REFERRAL REPORT

TO: Vancouver City Council
FROM: General Manager of Planning, Urban Design, and Sustainability
SUBJECT: CD-1 Rezoning: 450 West Georgia Street and 712-732 Richards Street

This report evaluates an application to rezone 450 West Georgia Street and 712-732 Richards Street. The proposal is for a 23-storey commercial office building with retail at grade. The total floor area is 34,902.8 sq. m (375,554 sq. ft.) and floor space ratio (FSR) is 15.65.

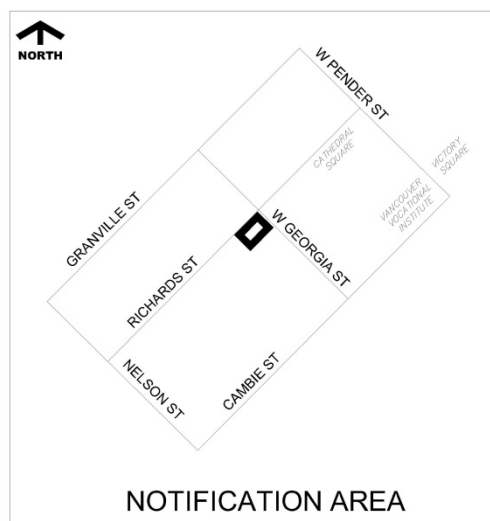
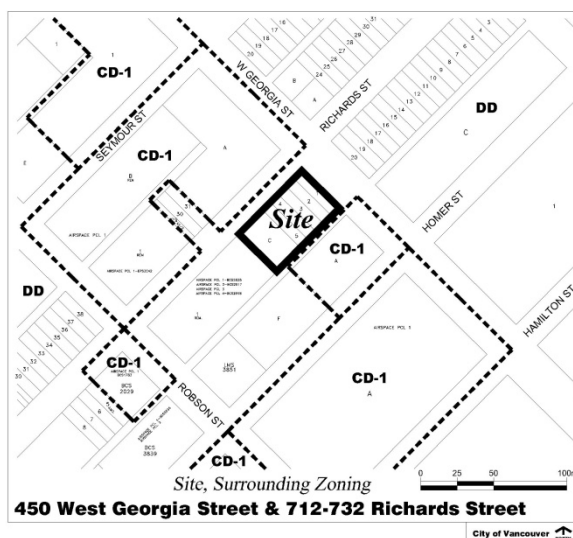
- Further develop the definition of the lobby and the public realm on W Georgia St.
- Explore simplifying the massing of the building.
- Explore ways to improve accessibility on Richards St.
- Design development to further consider solar shading design in particular creating a stronger contrast on the north elevation.
- Further consideration to the setback of the central circulation core, to facilitate increasing improved setbacks particularly to the side of the northern aperture.
